**MASTER DEVELOPMENT
DRAINAGE PLAN
FOR
ESTEBAN RODRIGUEZ SUBDIVISION SKETCH PLAN,
EL PASO COUNTY, COLORADO**

July 2023

Job No. 25277.00

PCD File No.: XXXX ← SKP237

EXISTING DRAINAGE MAP
ESTEBAN RODRIGUEZ SUBDIVISION-SKETCH PLAN
JOB NO. 25277.00
07/10/2023
SHEET 1 OF 1

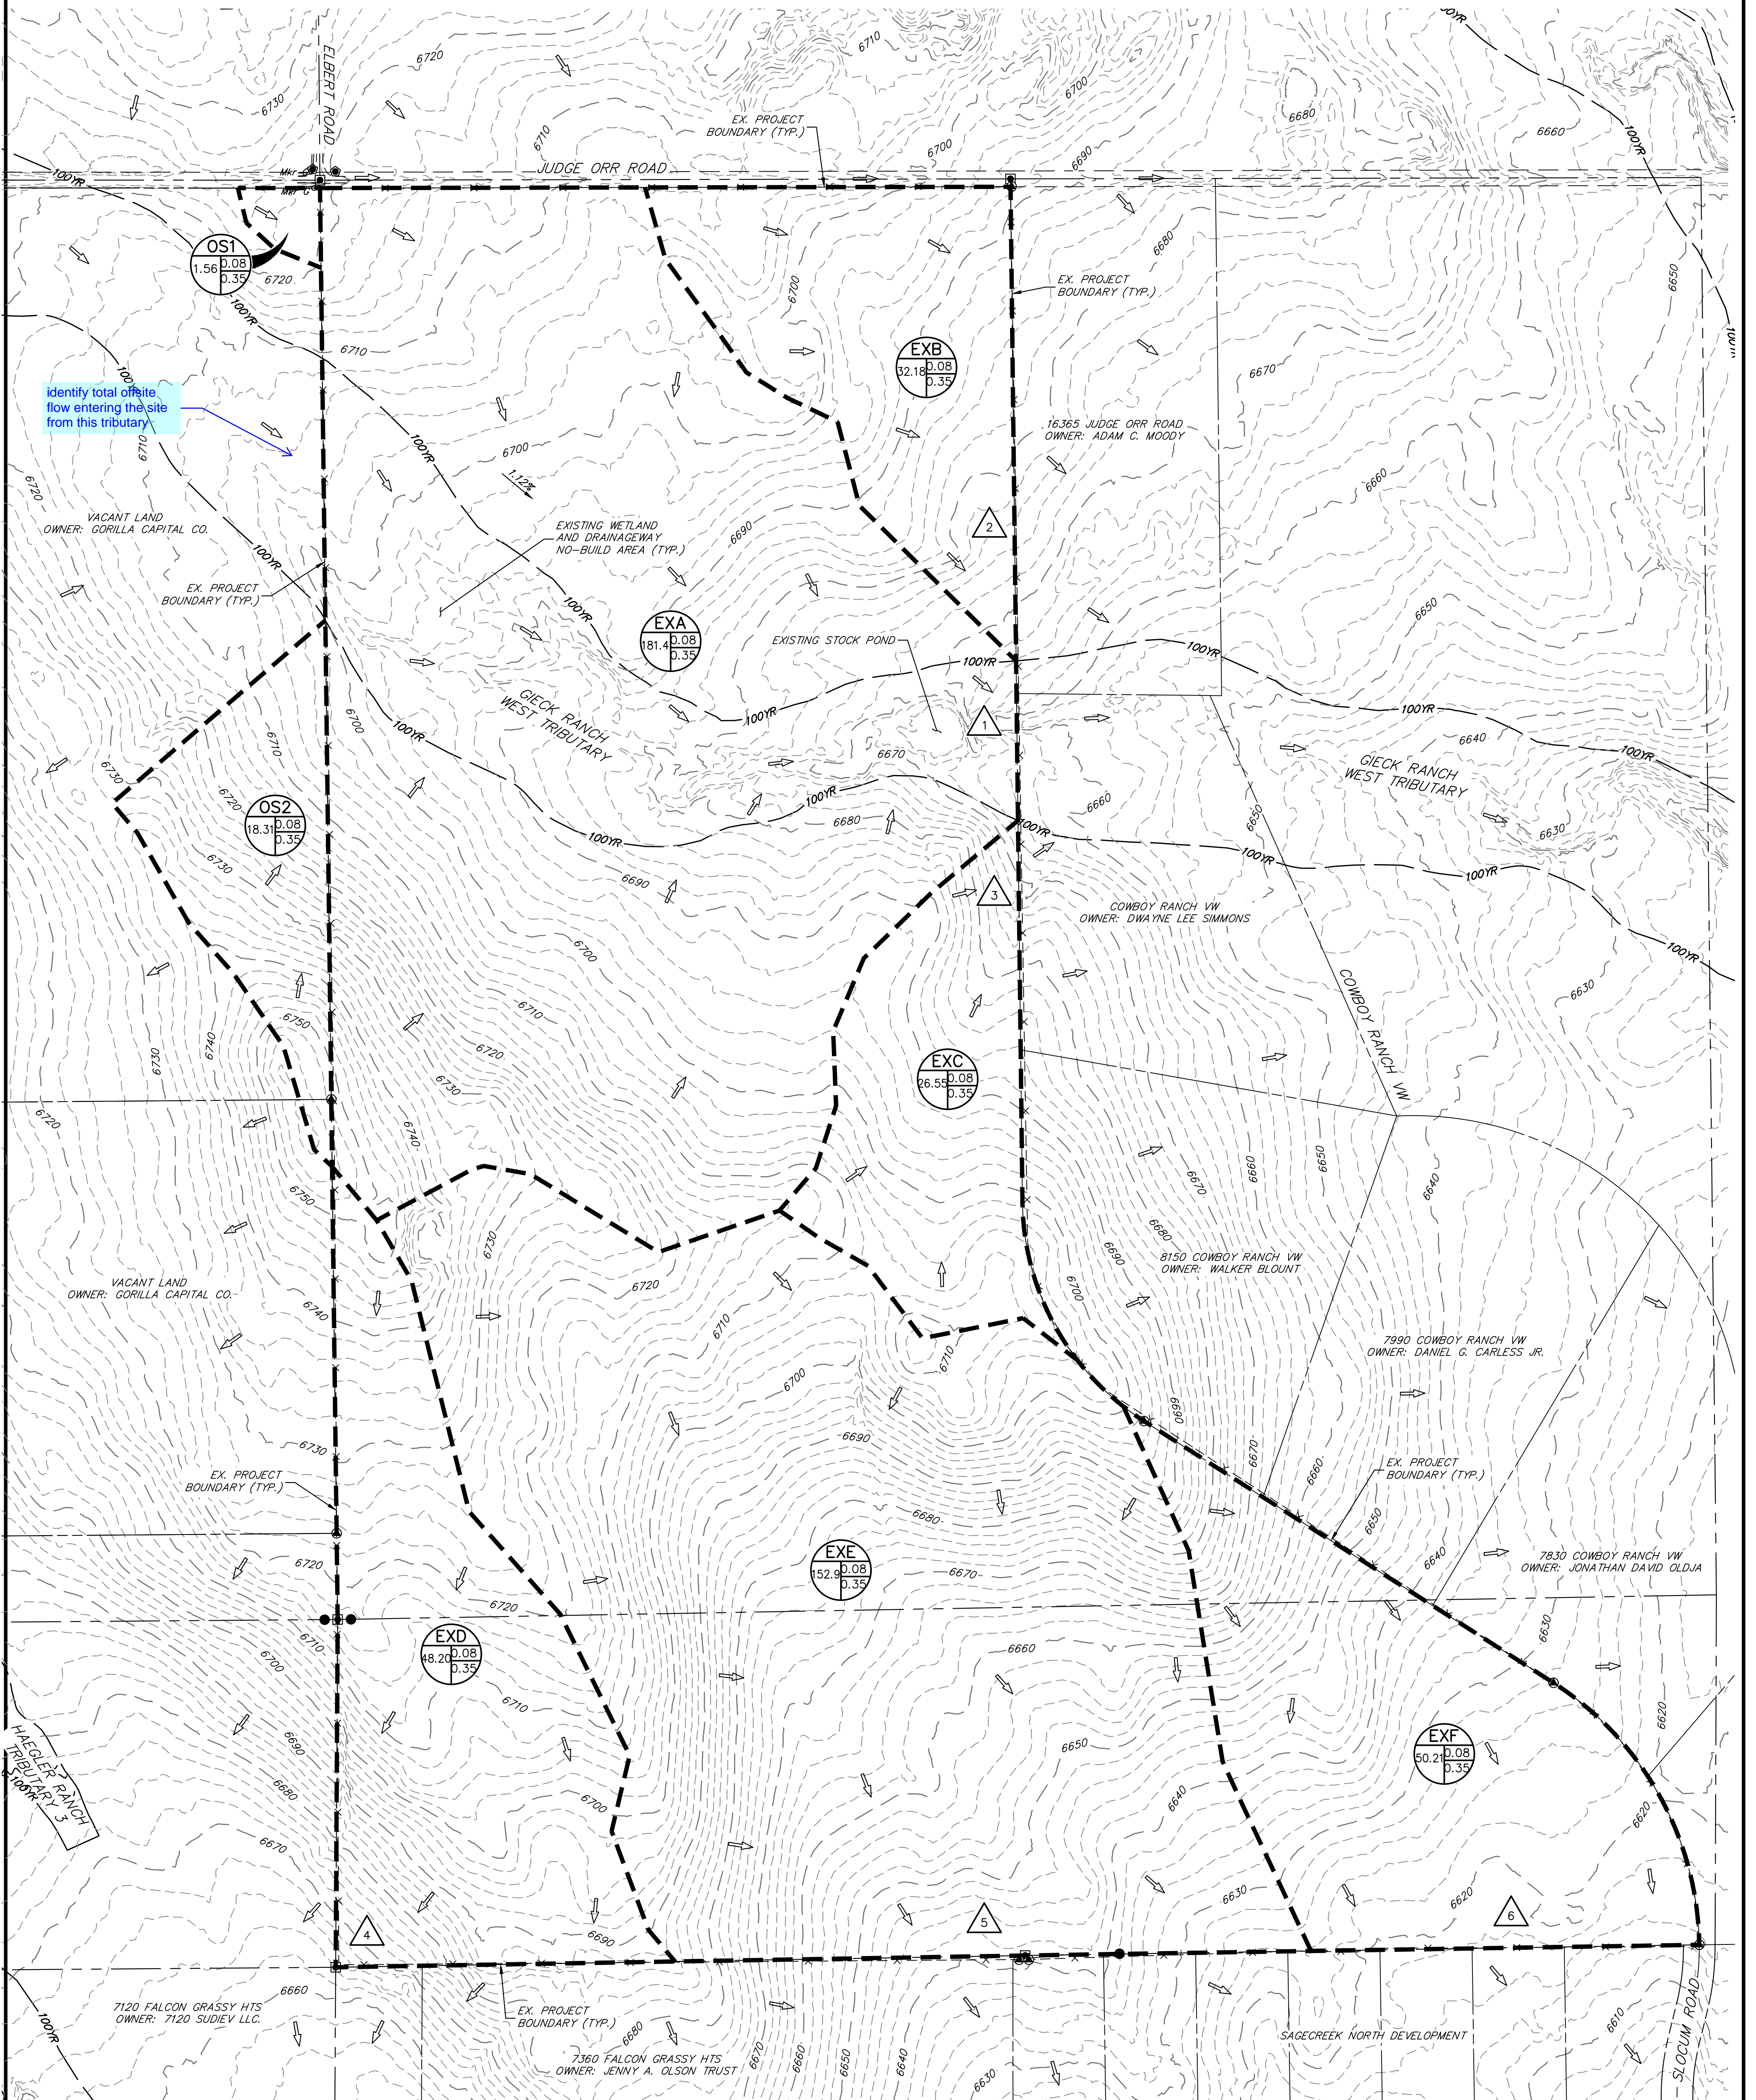
please provide a design point summary table for the existing conditions and developed conditions
